SERVICE BULLETIN

M-920

February 11, 1986

1986 1340cc IGNITION MODULES (Excluding FXRP)

Figure 1. Ignition Module Identification

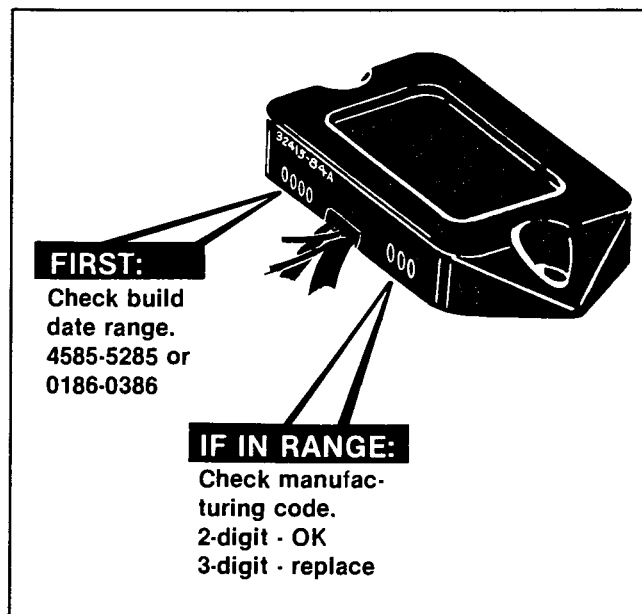
See Figure 1. Any module with a build date of 4585 through 5285, or 0186 through 0386 will require an additional inspection. If a module within these two build date ranges has a three digit manufacturing code it is suspect and must be replaced. Modules within the build date ranges that have a two digit manufacturing code will function properly and **ARE NOT TO BE REPLACED**.
